## **ADDENDUM #2**

### **Rye City School District**

***Issued: 2021-02-05***

**This Addendum No. 2 forms part of the Contract Documents and modifies the original bidding documents dated, January 19, 2021.**

SEAL & SIGNATURE DATE: 01/19/21  
PROJECT No: 9200  
DRAWING BY: Author  
CHK BY: Checker  
DWG No: A2-402

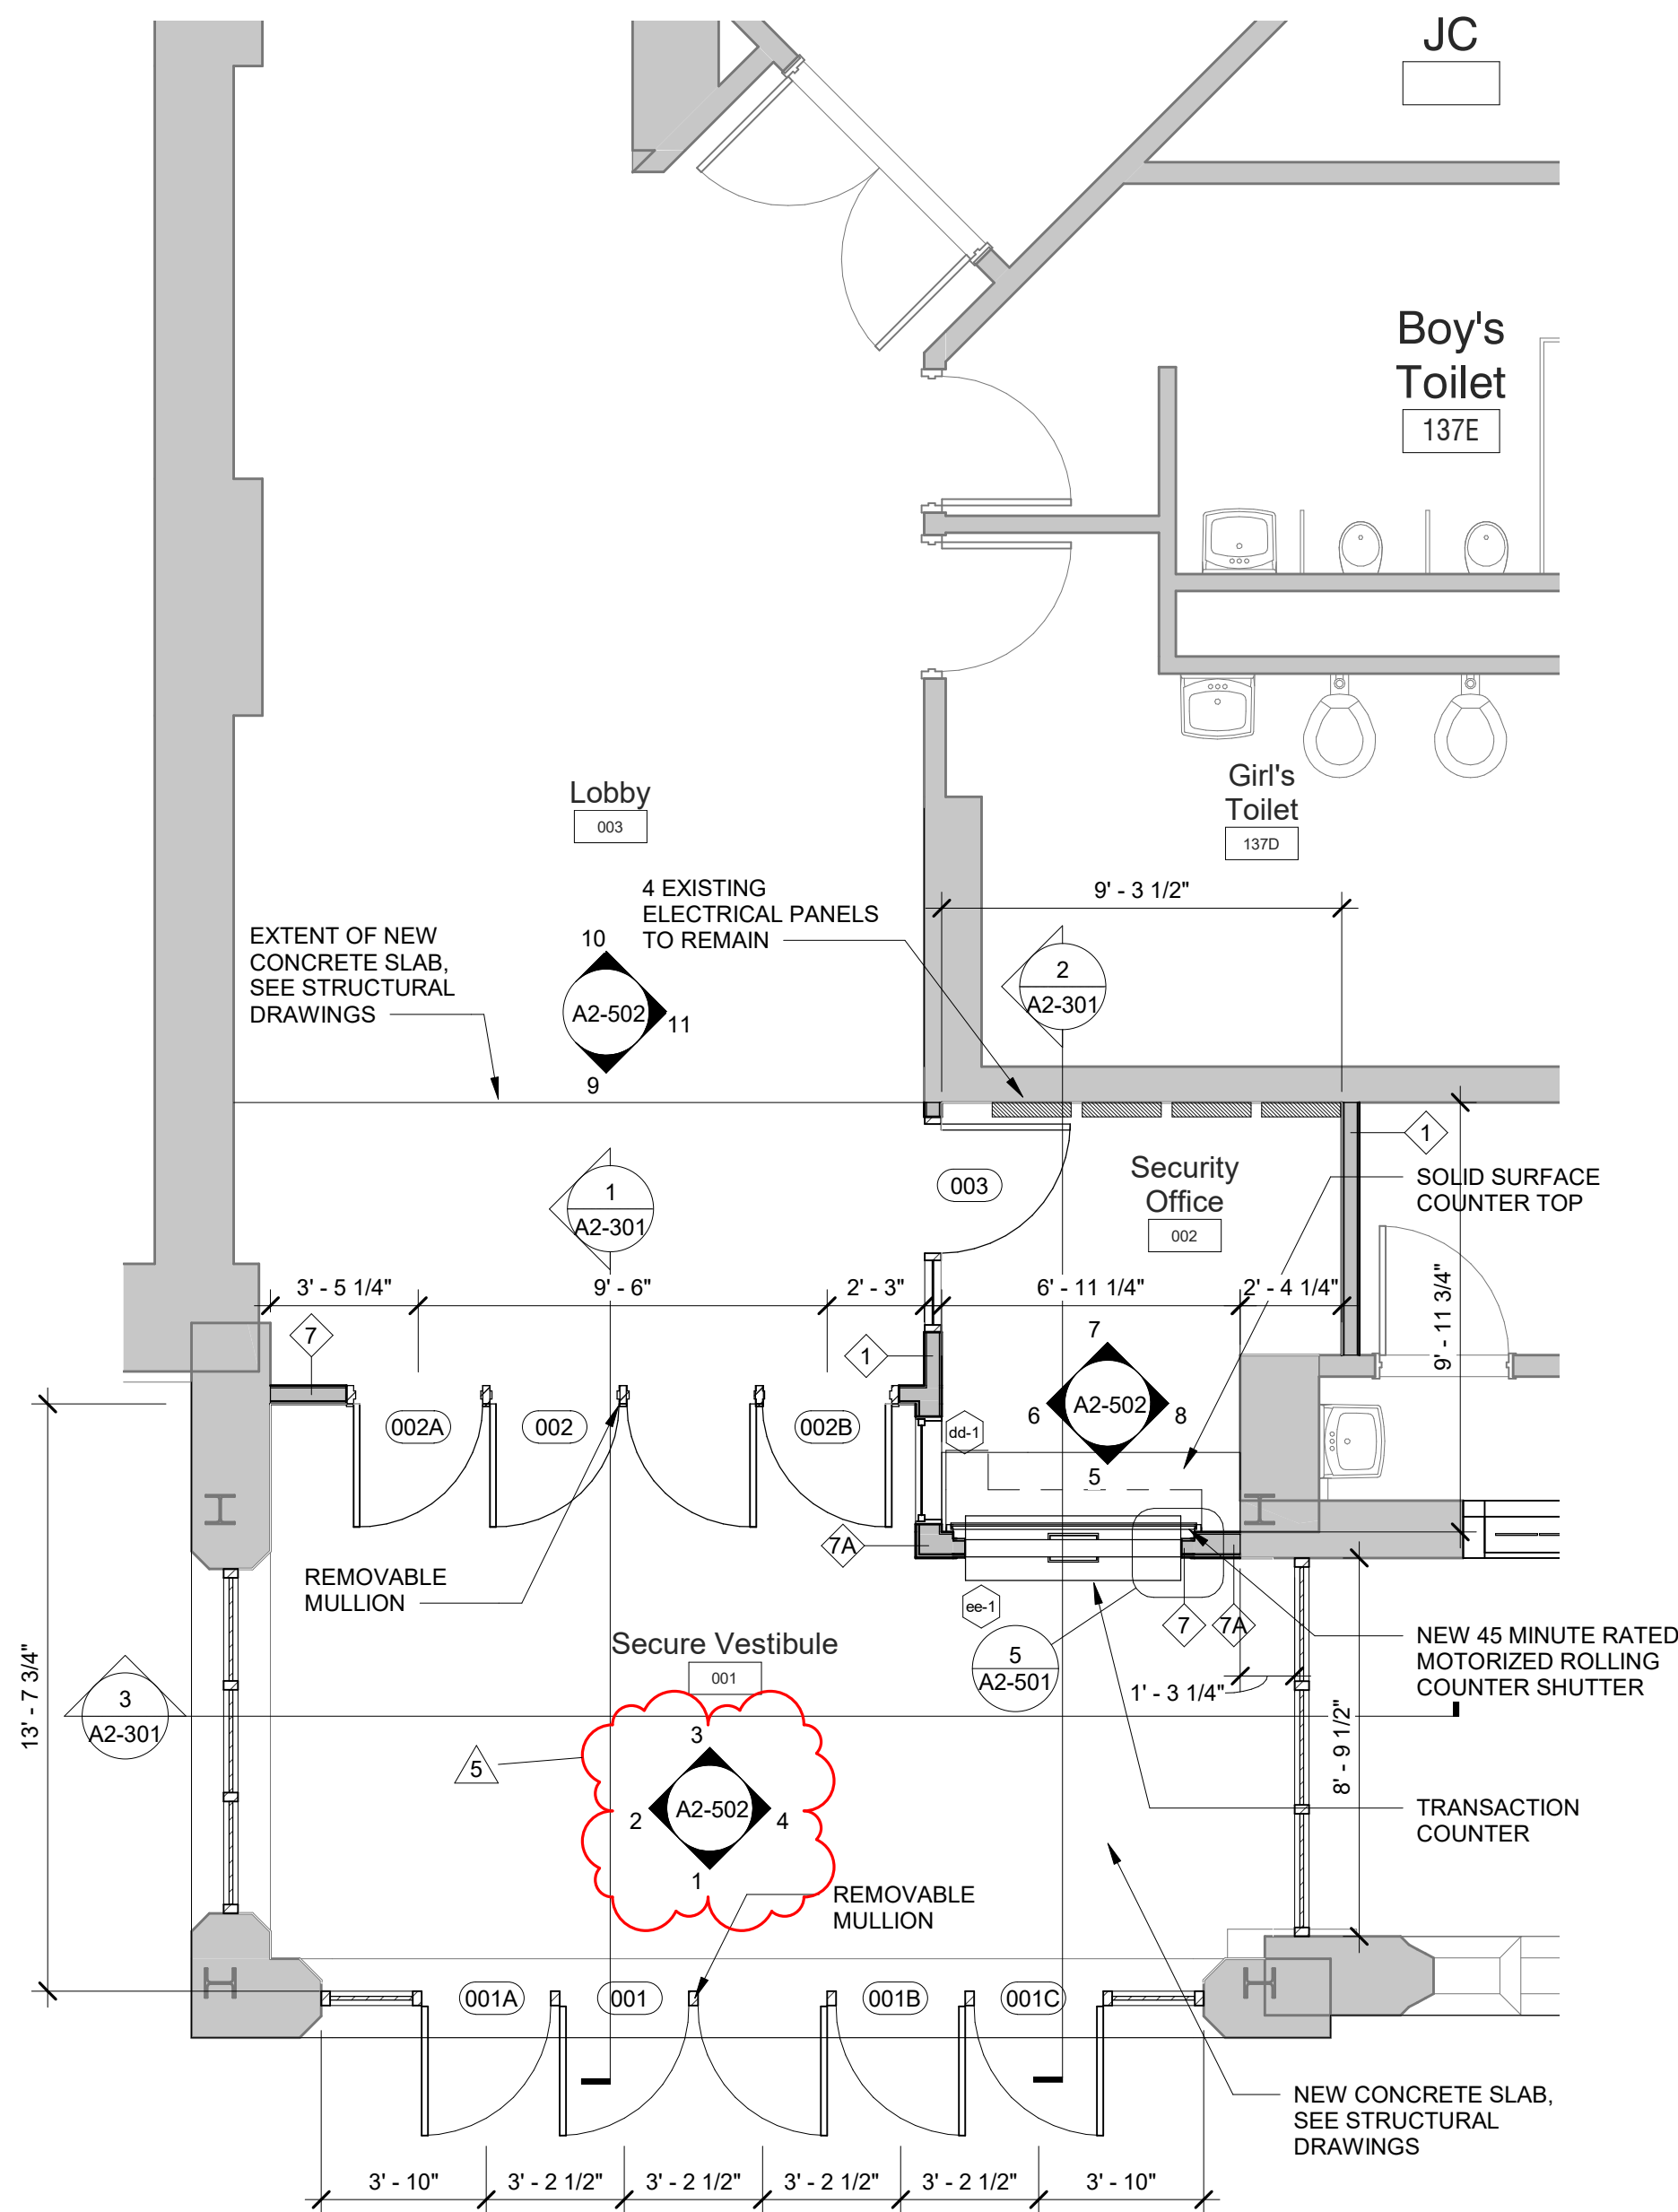
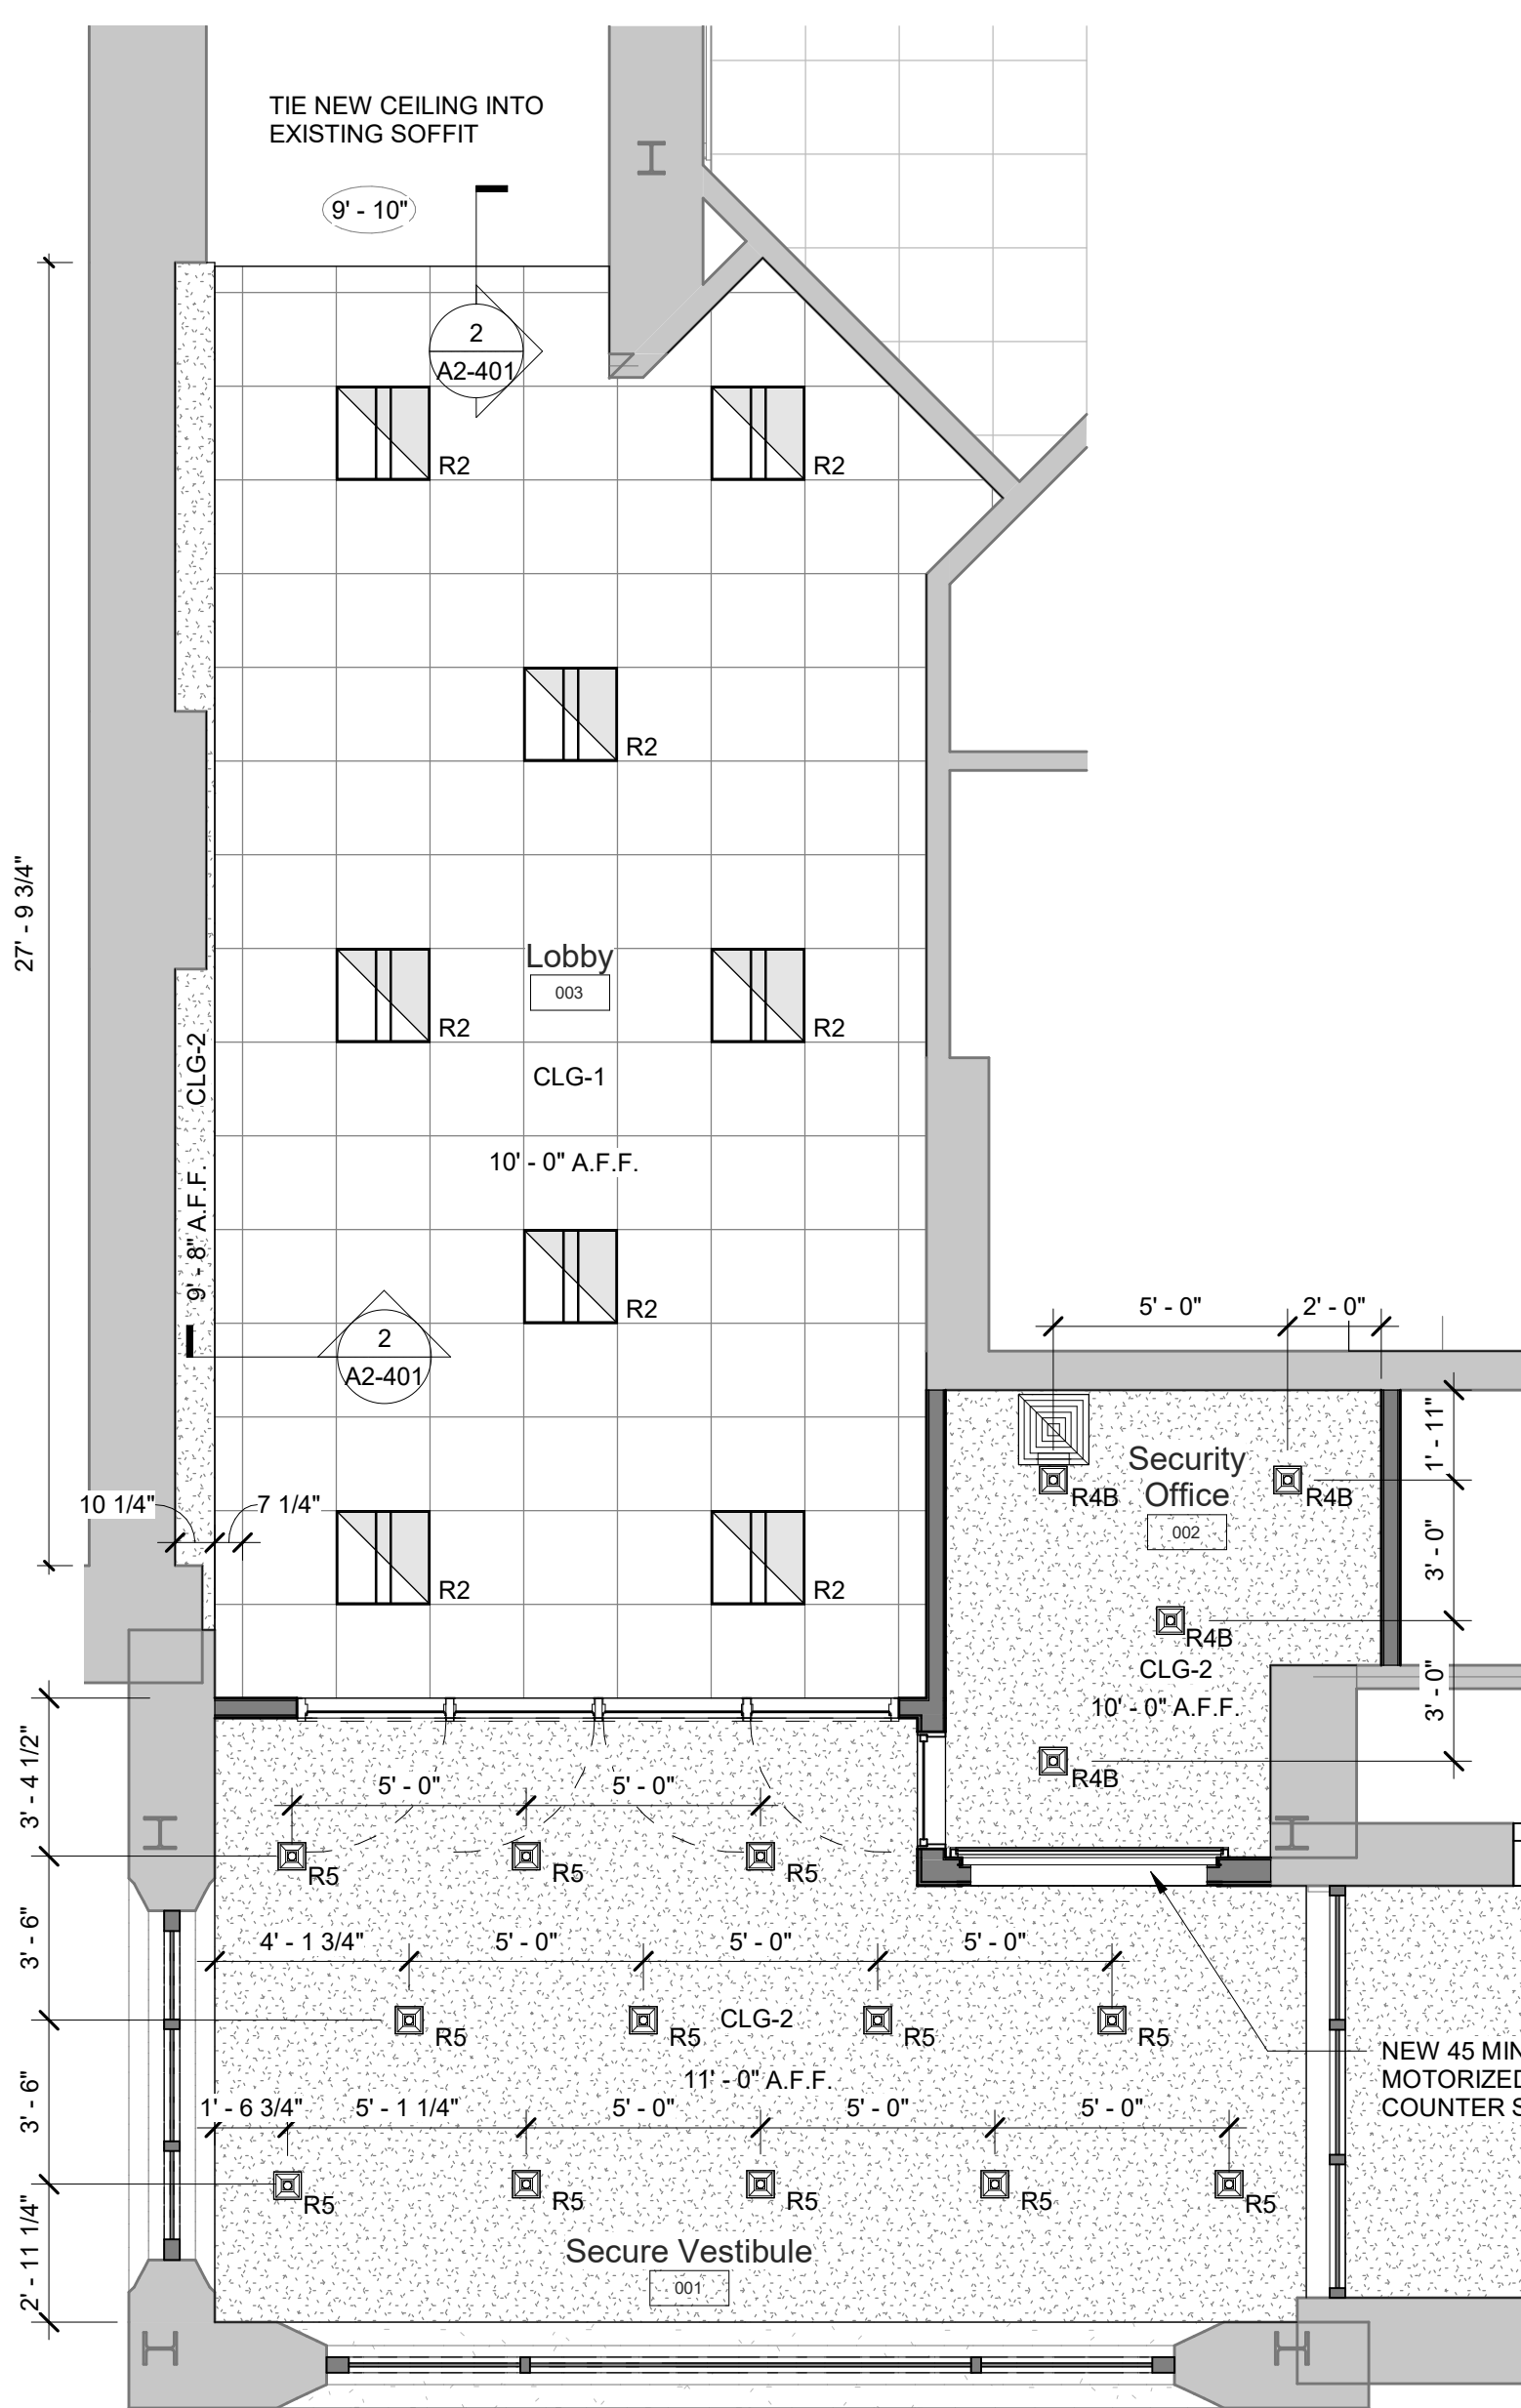
16. A2-402
  - a. Note added for ceiling removal and replacement outside of Classroom 209.
17. A2-501
  - a. Detail #2 – Interior Elevation tag updated to reference appropriate drawing.
